Manchester Ice Nucleus Counter (MINC) measurements from the 2007 International workshop on Comparing Ice nucleation Measuring Systems (ICIS-2007)

Jones et al., Atmos. Chem. Phys. Discuss., 10, 19277–19307, 2010.

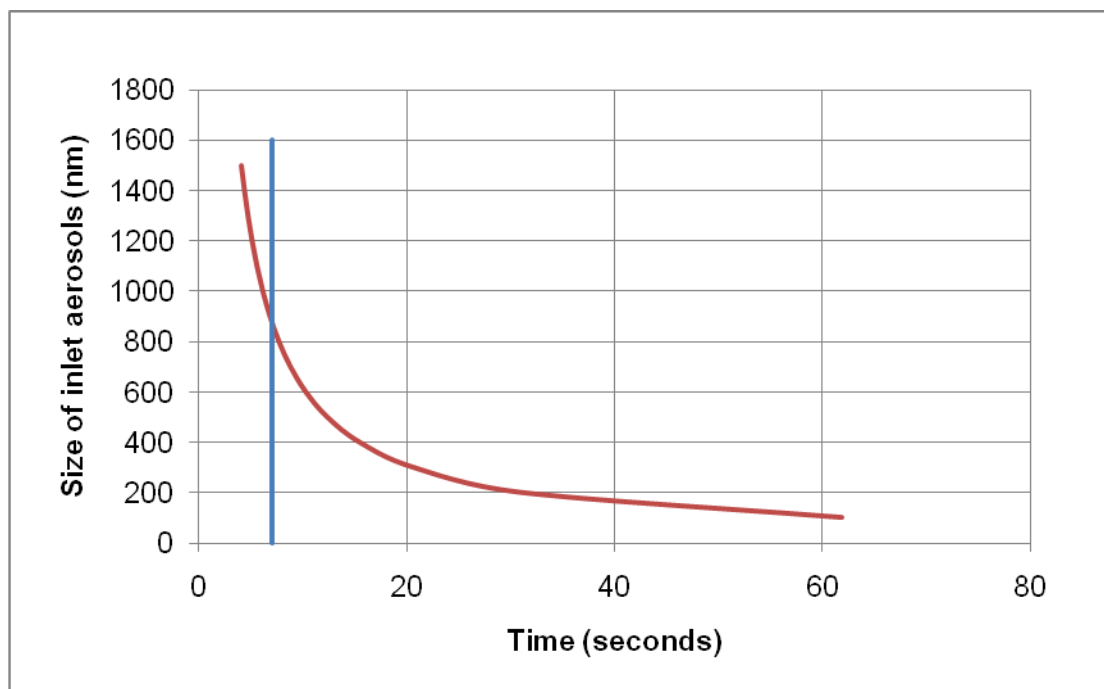
Line 23-28: It seems the onset detection limit for MINC is 94% RHw, which is also approximately 128% RHice at -32 deg C. Please mention why chamber design geometry could be responsible for the higher onset. A simple water vapor diffusion growth equation can be used to calculate the time (t) required to grow a particle to a detectable limit (r_2) at -32 deg C and $RH_{ice} = 128\%$, as follows, $t = (\rho_{ice} \cdot r_2^3) / (3 \cdot r_1 \cdot D \cdot \Delta p)$, where r_1 is sample inlet size of aerosols, D is diffusivity of water vapor and ρ is density. If we assume 7 second residence time within the nucleation chamber (not evaporation section) and OPC size detection lower threshold of 3 micrometers, the equation can be used to plot detection threshold limits. See following Figure. The blue line is marked at 7 second time, which crosses the red curve at ~900 nm size. This means the ice chamber can be used to investigate the ice nucleation efficiency of particles larger than 900nm only. The Figure shows sample inlet aerosols of size 300 nm will grow to 3 micrometers (OPC detectable limit) within ~ 20 seconds, but chamber has residence time of less than 20 seconds which means particles will grow to the size less than 3 micrometers and will cross the OPC undetected. These details including how to improve the detection limit should be mentioned in the paper.

Line 17-20: If residence time is assumed as 4 seconds, then from above Fig. the particles less than ~1300 nm cannot be detected because smaller particles do not grow to OPC detectable size threshold (3 micrometers). Figure 7b shows the particle size distribution with upper limit of 1000 nm. This raises the question that how many particles were present above 1000 nm in the APC chamber. Please mention these uncertainties and its influence on the active fraction calculations.
